Docket Item # 1
BAR CASE #2011-0362

BAR Meeting
March 7, 2012

ISSUE: Certificate of Appropriateness
APPLICANT: Allen & Rebecca Weh by Christine Kelly, AIA
LOCATION: 400 N Union Street
ZONE: RM / Residential

STAFF RECOMMENDATION: Staff recommends approval of the Certificate of Appropriateness, as revised, to include the new dormer designs and painting the masonry with a historically appropriate color, per the Design Guidelines.

Figure 9: Second submittal for proposed front (east) dormer (3/7/2012).

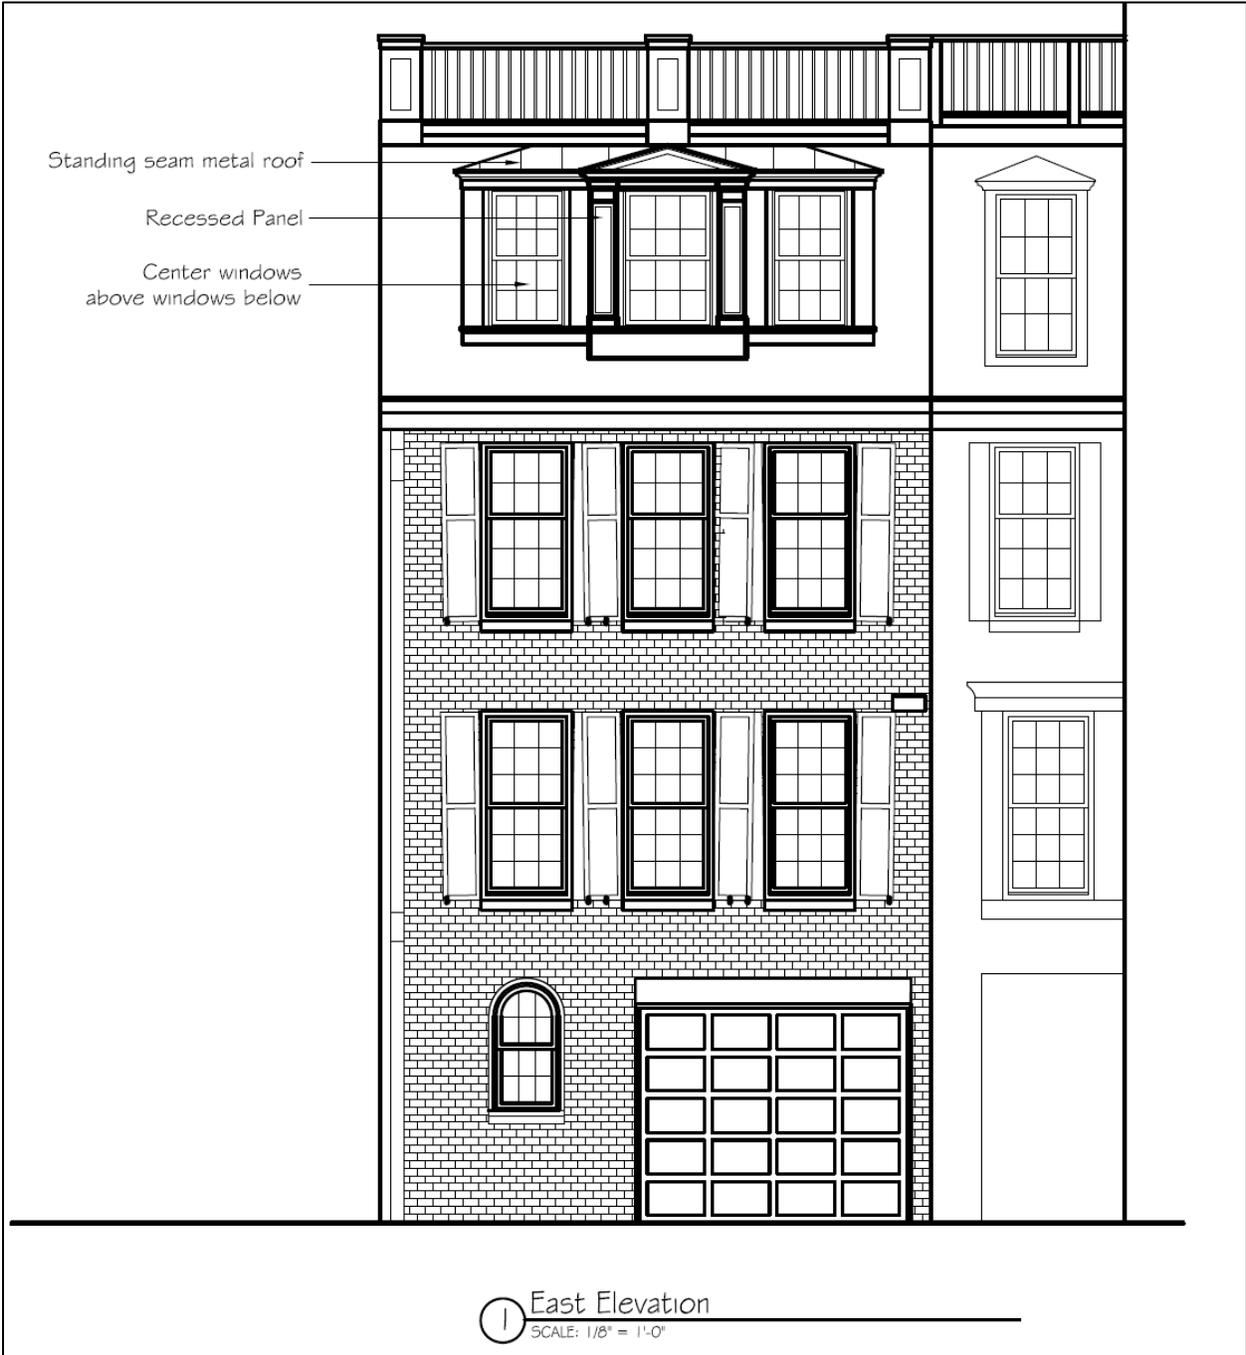
While Staff and the Board did not support the initial Palladian style dormer, Staff commends the architect on the new front (east) dormer design. The new design is still functionally a shed dormer however the roof lines and the projecting center window allow the dormer to visually appear smaller and in better scale with the structure below. The center window is pulled out 8" from the windows on either side, which is the opposite of the rear dormer that recesses the center window in by 8". This difference in projection creates a sense of hierarchy in the dormer and features the central window with a high level of architectural detail. It is also important to note that the three windows on the front dormer now align with the rest of the windows on the front façade, which creates balance. The architect also added paneled detailing in both the gable and vertical side bands of the focal point windows, recalling the rooftop guardrail plinths and the shutter panels below. These details create a more high style dormer than the original submission and it is more architecturally integrated with this large Colonial Revival townhouse. Staff recommends the approval of the revised front former design.

Figure 10: Second submittal for redesign of approved rear (west) dormer based on redesign of proposed front (east) dormer (3/7/2012).

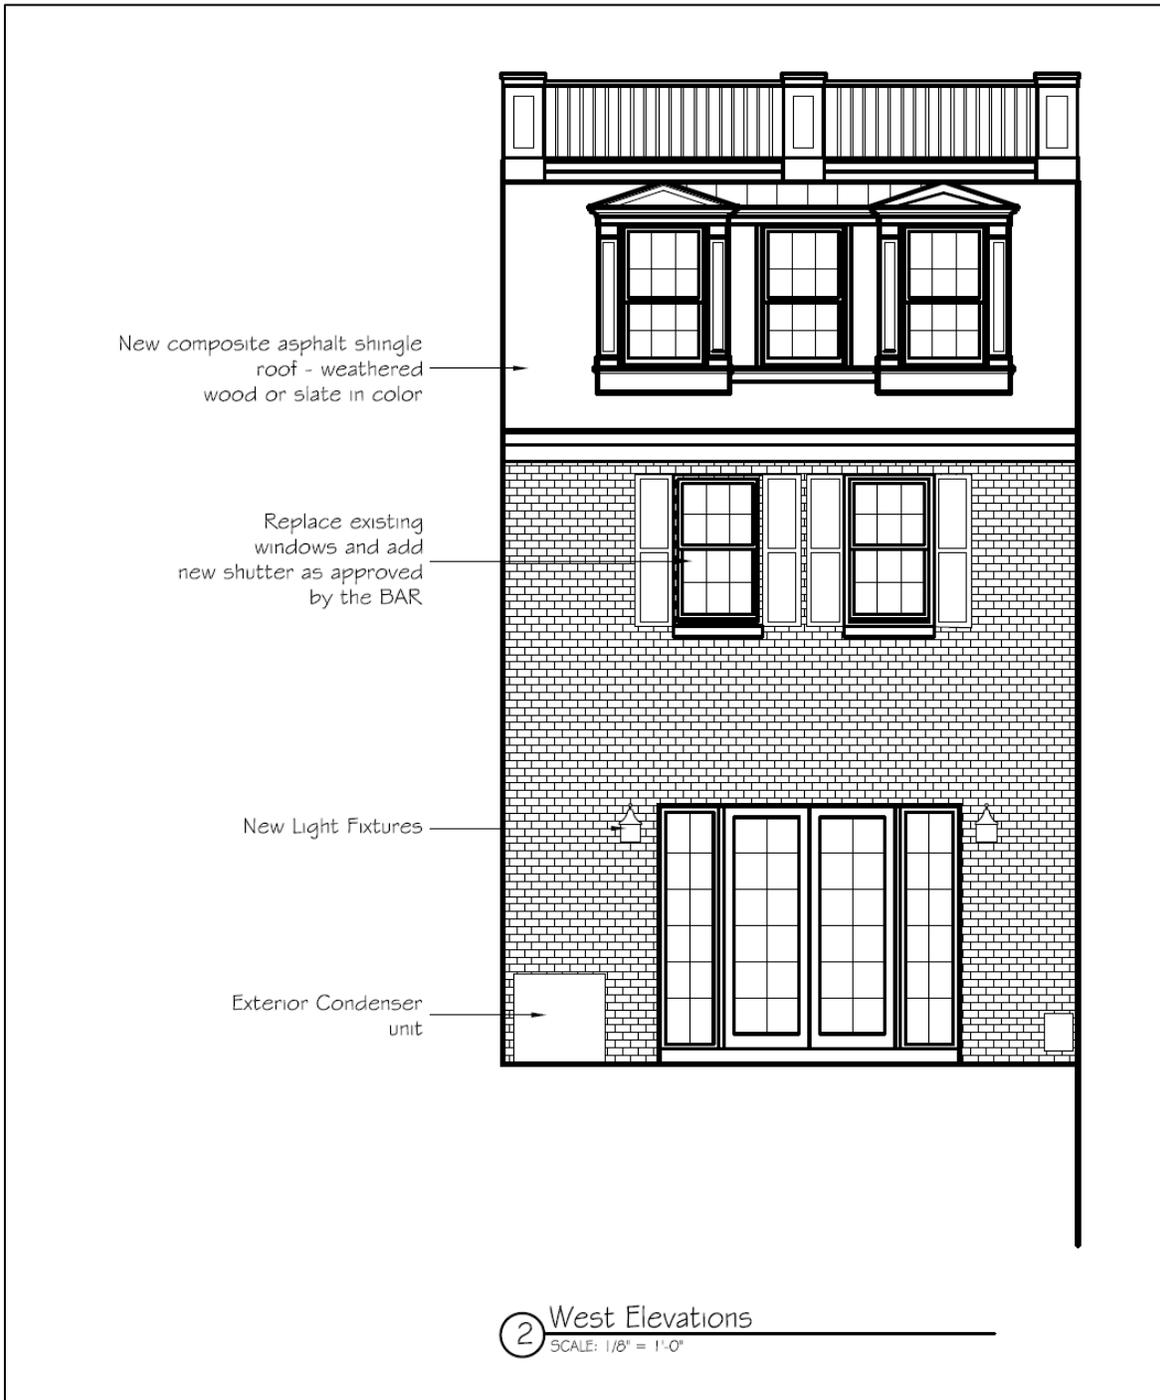
The architect made small design changes to the details on the previously approved rear dormer to reflect the design of the revised proposal for the front dormer. Staff supports these changes because it creates an integrated architectural design.
